## PRO PCB ISSUES 2022-04-06

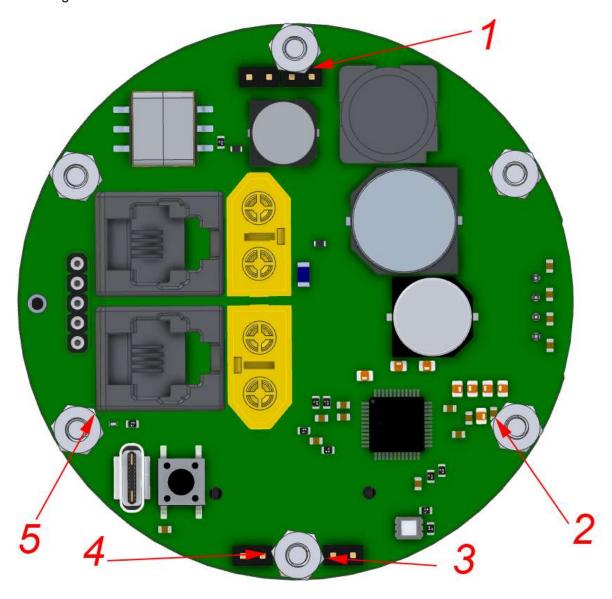
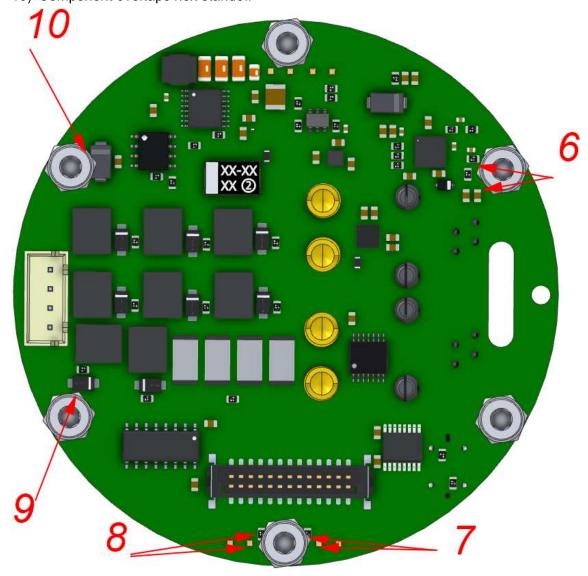
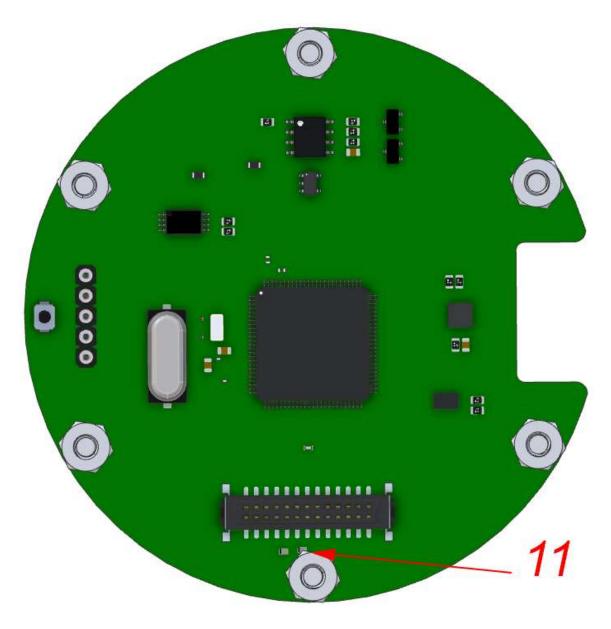
- 0) The bottom PCB has a slightly larger diameter than the top PCB? Why?
- 1) Connector overlaps the hex standoff
- 2) Component overlaps hex standoff
- 3) Component overlaps hex standoff
- 4) Component overlaps hex standoff
- 5) Component almost overlaps hex standoff (move the two black connectors slightly closer together.

- 6) Component overlaps hex standoff
- 7) Component overlaps hex standoff
- 8) Component overlaps hex standoff
- 9) Component overlaps hex standoff
- 10) Component overlaps hex standoff

11) Component overlaps hex standoff
